# Sun Storage 6180 Array Release Notes

Release 6.5

Part No. 821-0265-11  
March 2010, Revision A

**FIGURE 1** Sun Storage 6180 Array DC Power Option (Rear)

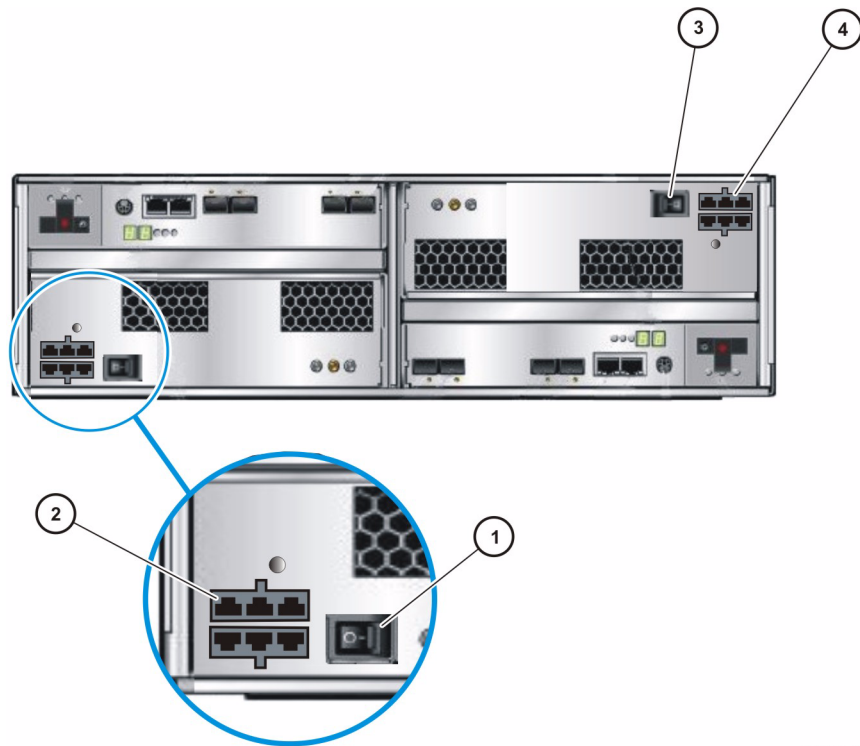
The *Sun Storage 6180 Array Hardware Installation Guide* does not include an illustration of the optional DC Power connectors.

Correction—[FIGURE 1](#) shows the location of the DC power connector and DC power switch at the back of each controller.
